# COMMISSION OF ARCHITECTURAL REVIEW

## APPLICATION FOR CERTIFICATE OF APPROPRIATENESS

Address 807 N 24th Street  
Historic district Church Hill North

### **807/809 North 24<sup>th</sup> Street**

sheet title  
**BUILDING ELEVATIONS**

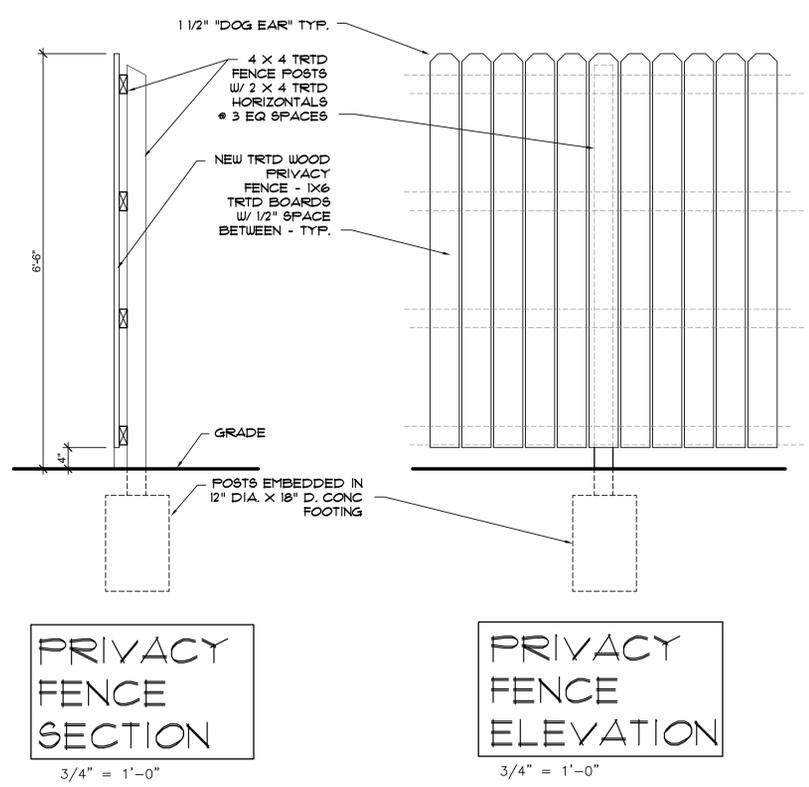
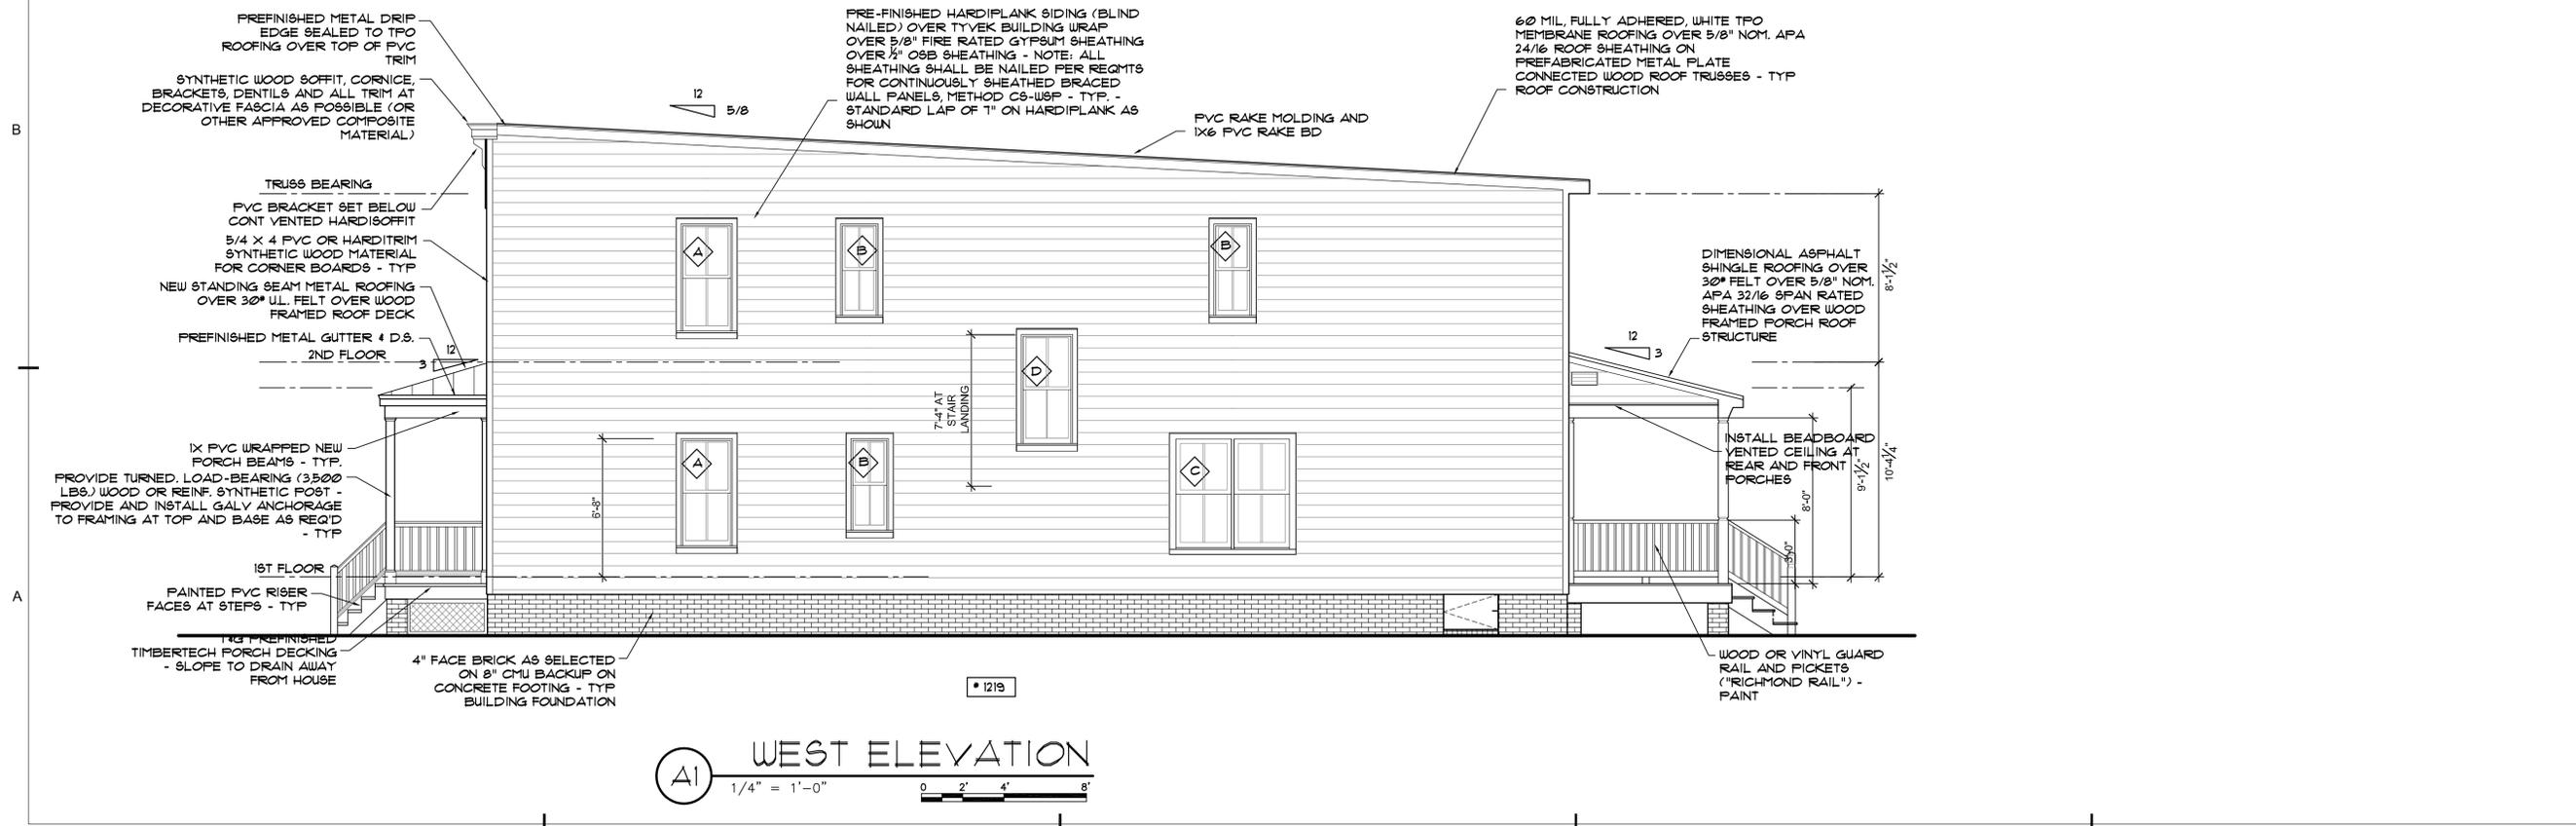
The revised plans show the correct window sizes with fenestration realignment requested by Chairman Klaus. The paintable PVC window sample was dropped left with CAR staff on December 20, 2019. The cornice brackets have been aligned per Mr. Hendricks' request.
